RE: **Lot 17 Block 9 Unit 22, S.A.D. 228**
6427 Petirrojo NW
Grading and Drainage Plan
Engineers Stamp Date 12-6-17 (D10D003Q17)

LOT 17 BLOCK 9
UNIT NO. 22
VOLCANO CLIFFS SUBDIVISION
GRAPHIC SCALE

DRAINAGE PLAN

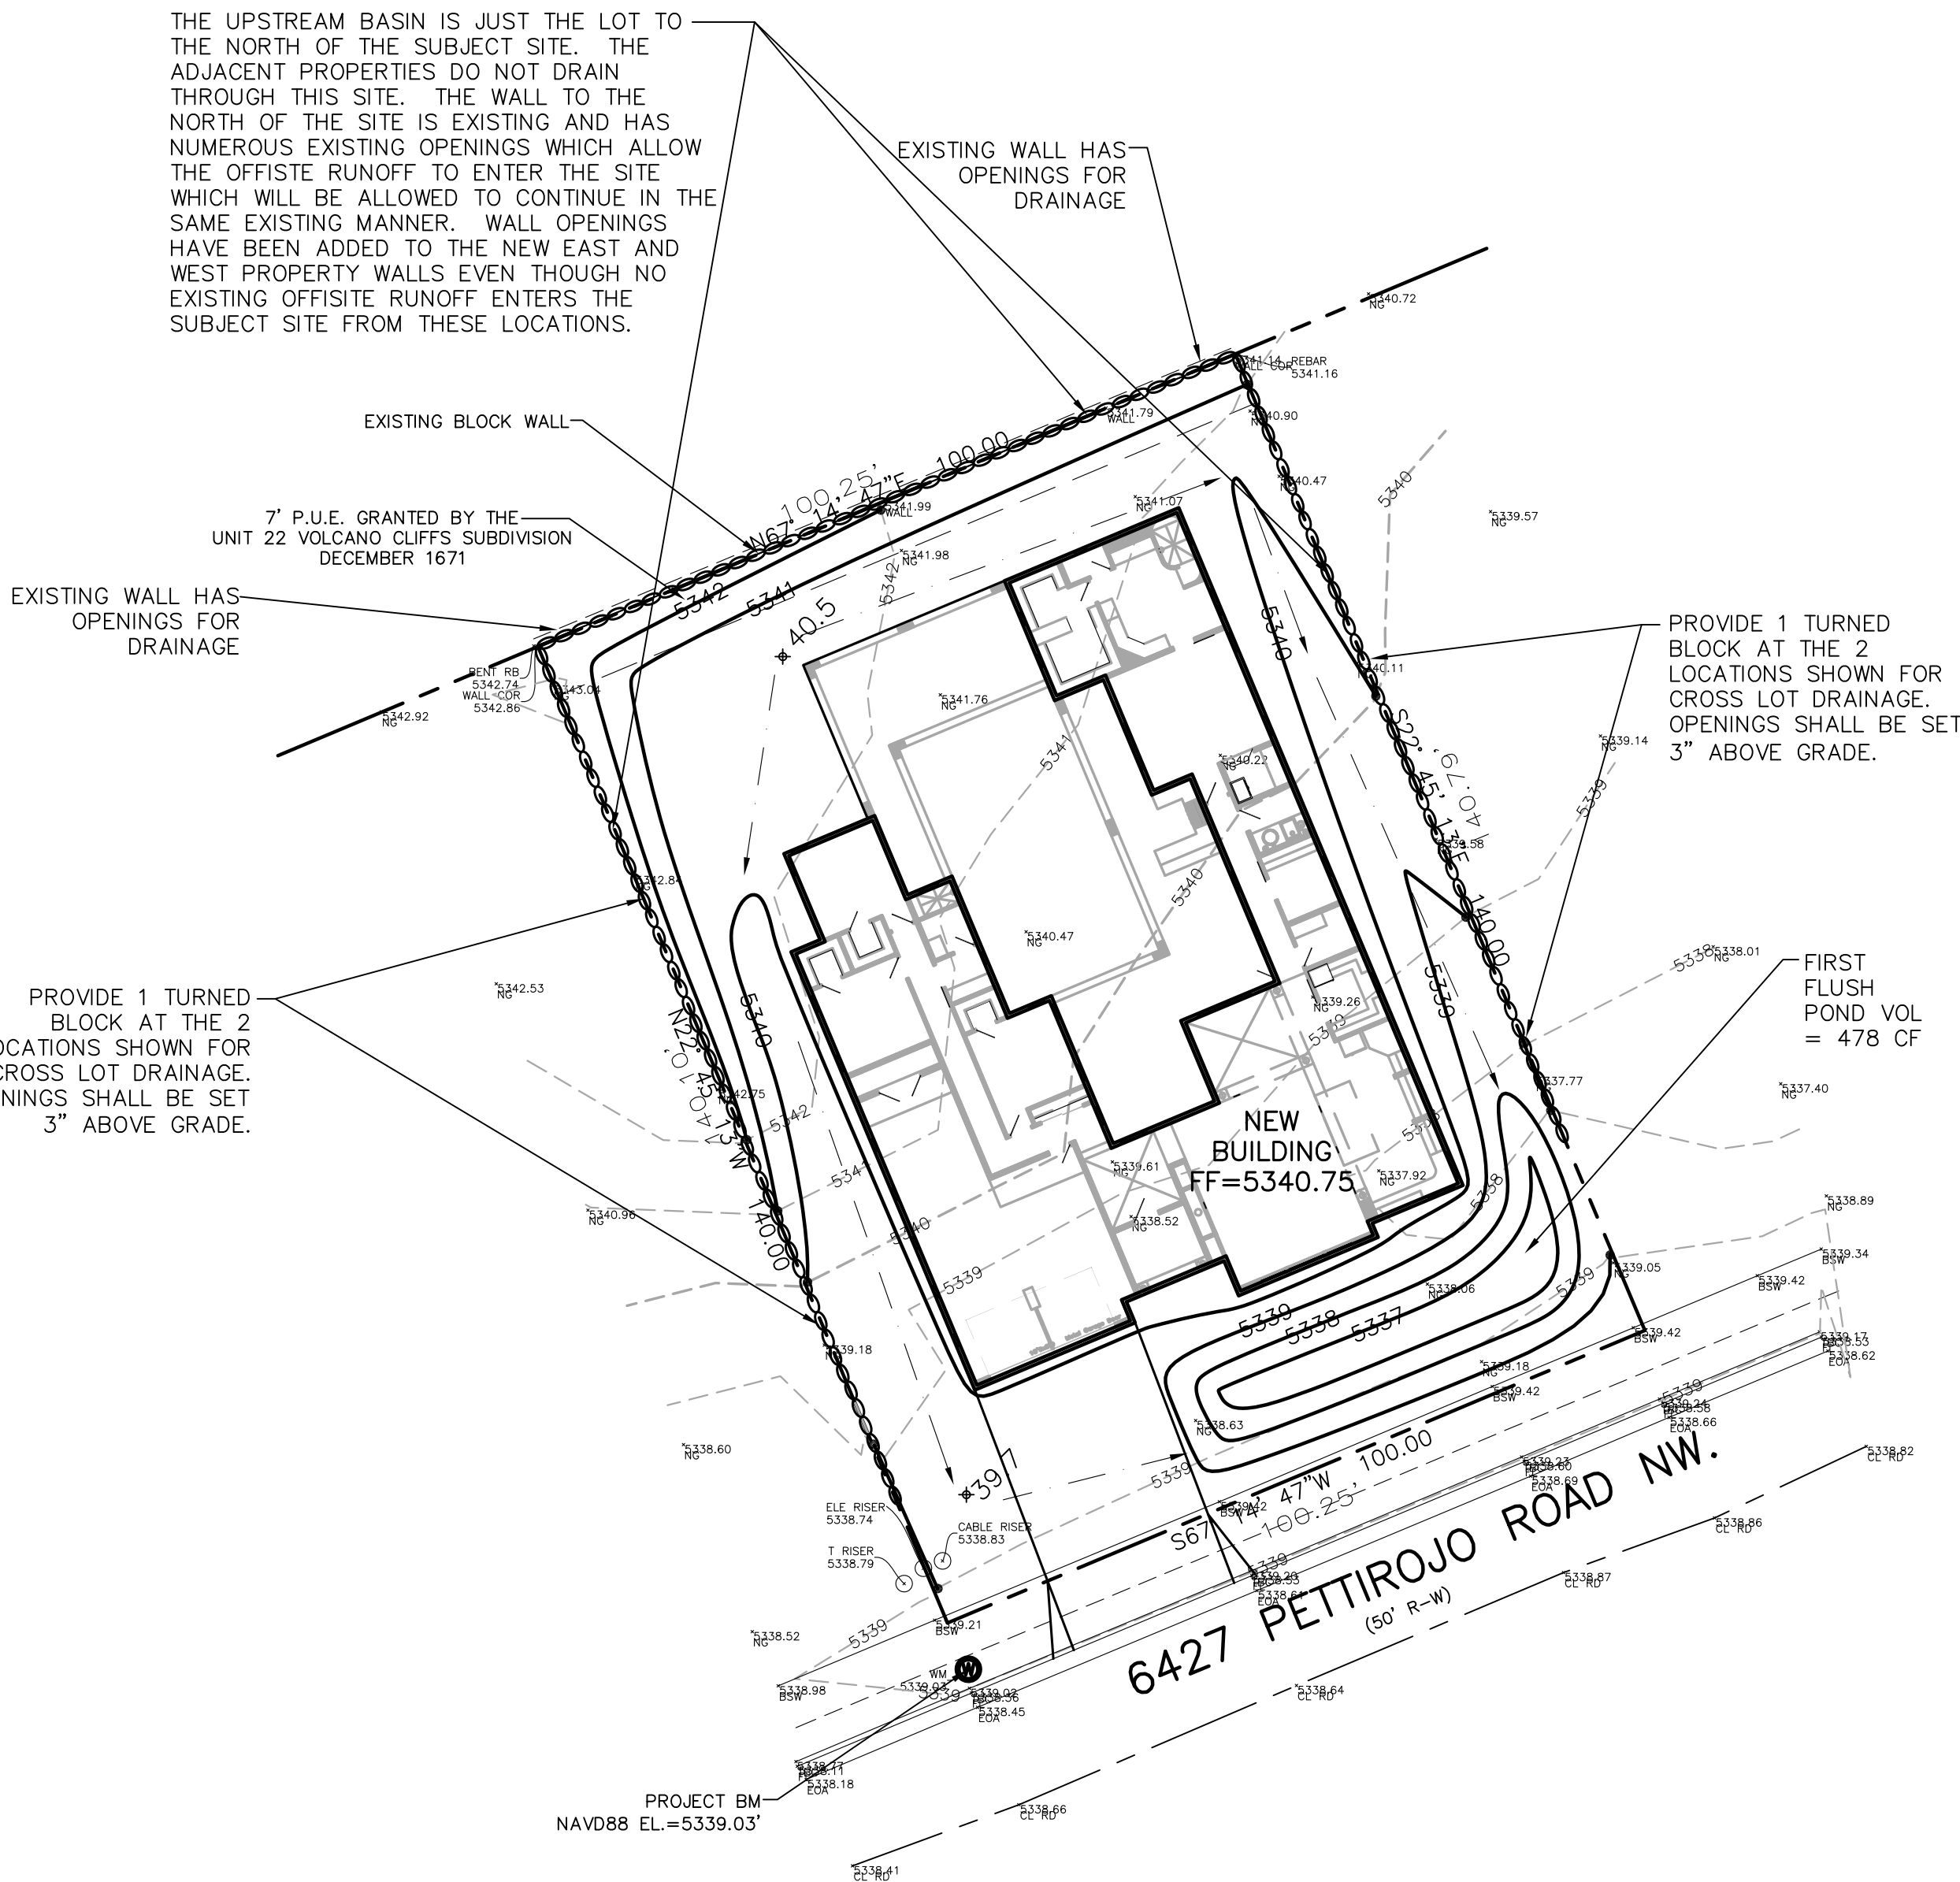
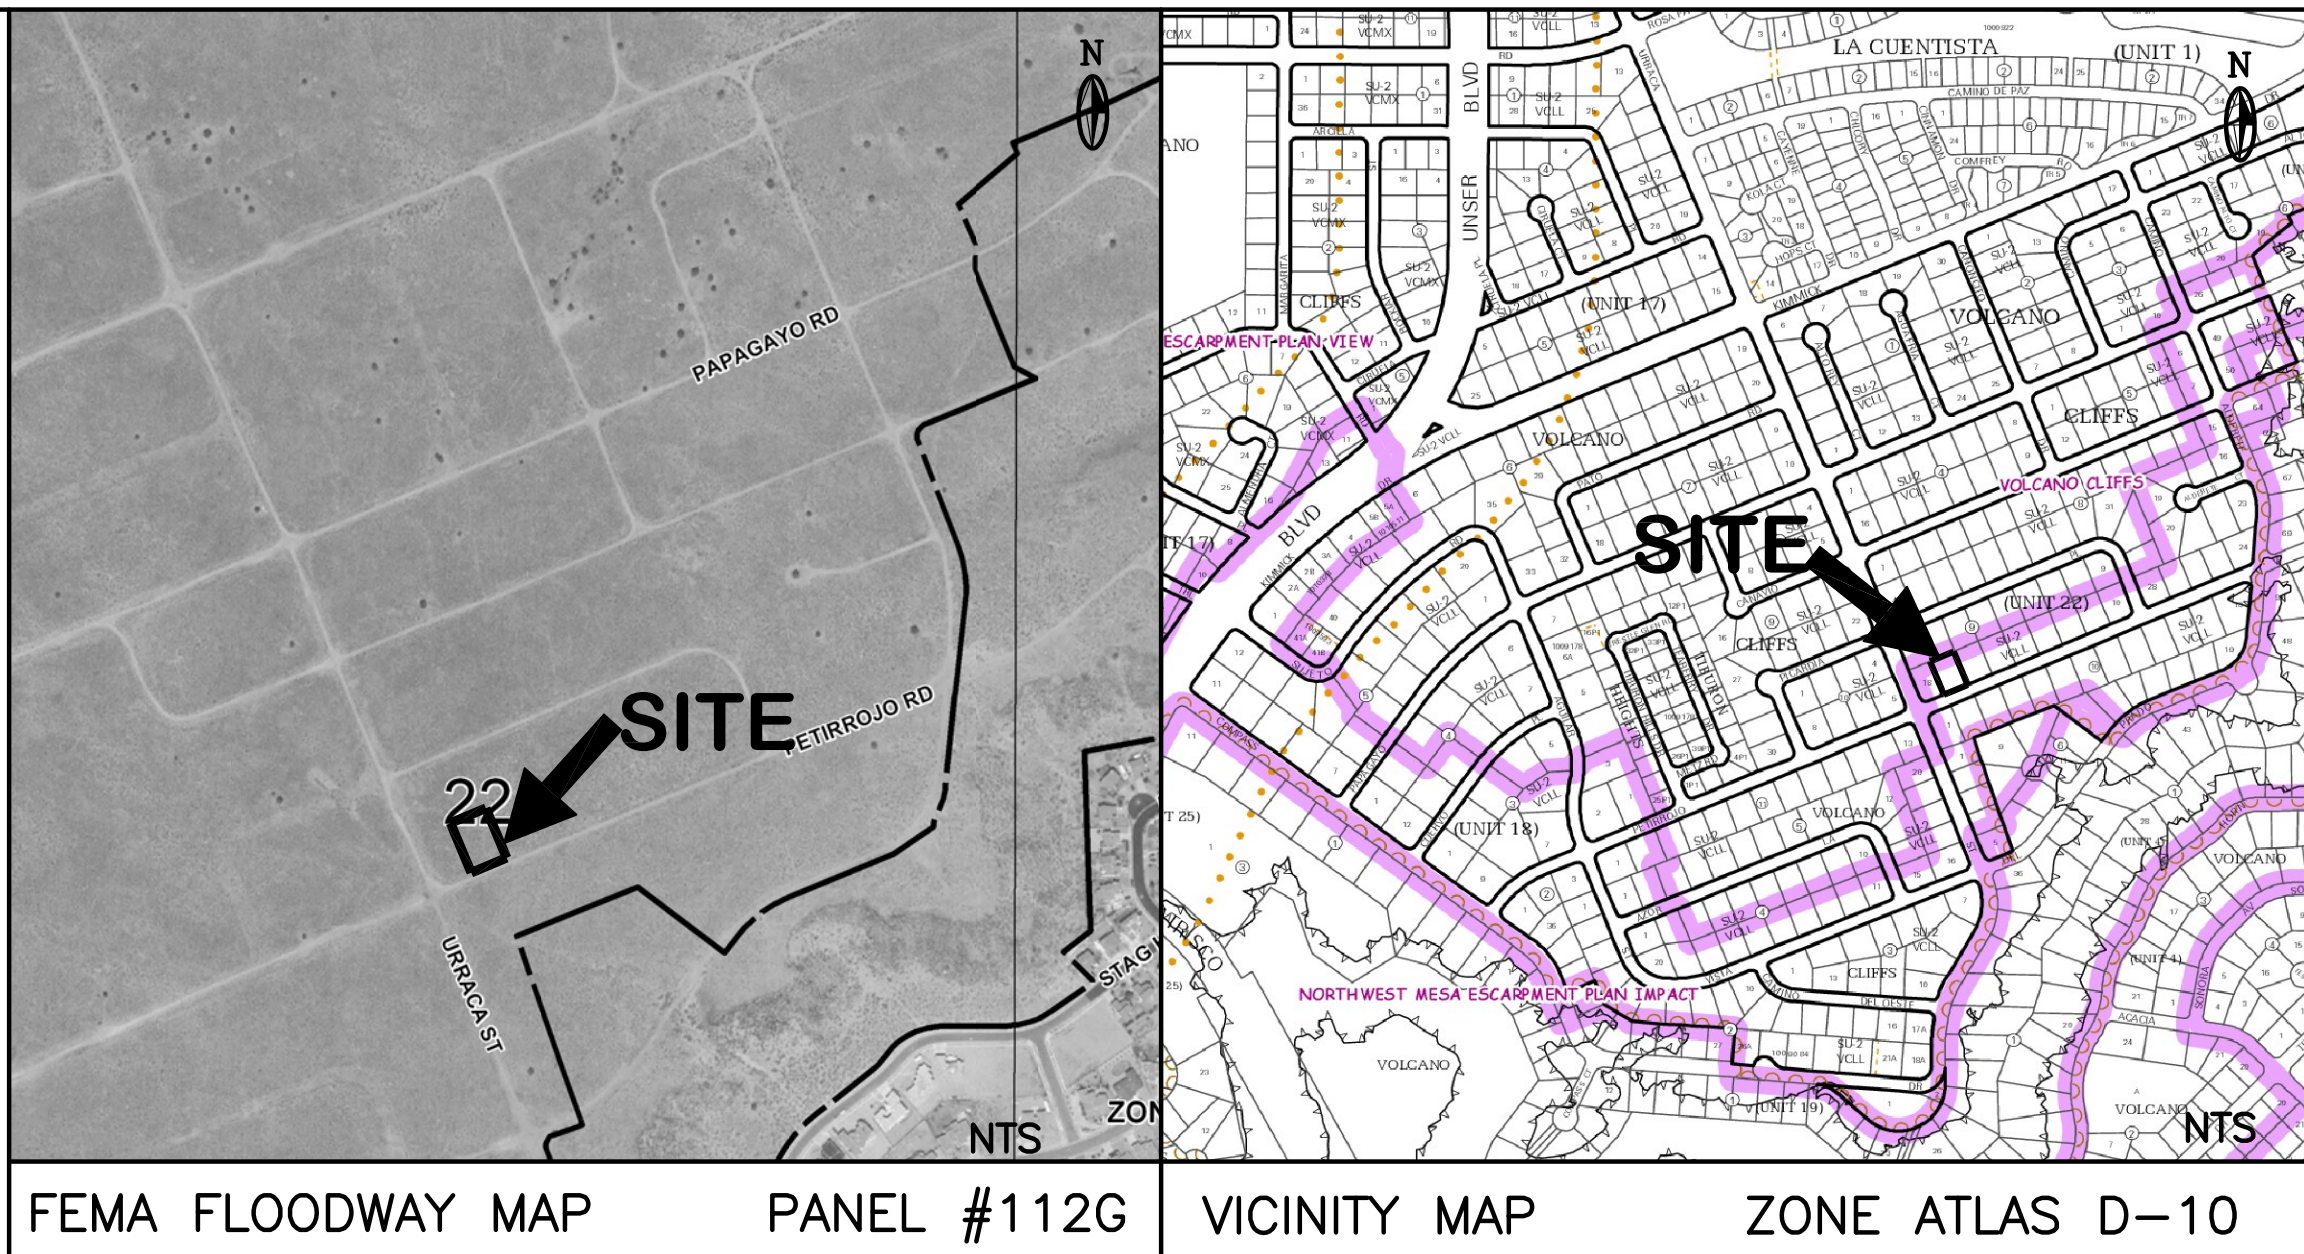
- Provide how the flows will enter and exit the rear yard from west to east. It appears the retaining walls will stop these flows.
- Provide the amount of flow entering and exiting the rear yard.
- Provide the size of the openings and calculations for the turn blocks, to show that the openings are sufficient for the passage of the flows required.

This is the plan to be used for any garden walls and any openings in the walls shall be placed 3" above final grade in the rear yard to allow for cross lot drainage from west to east (upstream to downstream).

PROPERTY LINE WALLS AND GARDEN WALLS SHALL HAVE TURNED BLOCKS OR WEEP HOLES FOR DRAINAGE. ALL OPENINGS IN THE WALLS SHALL BE 3" ABOVE GRADE.

- Provide how the flows will enter and exit the rear yard from west to east. It appears the retaining walls will stop these flows. **provided on plan**
- Provide the amount of flow entering and exiting the rear yard. **provided on plan**
- Provide the size of the openings and calculations for the turn blocks, to show that the openings are sufficient for the passage of the flows required. **provided on plan**
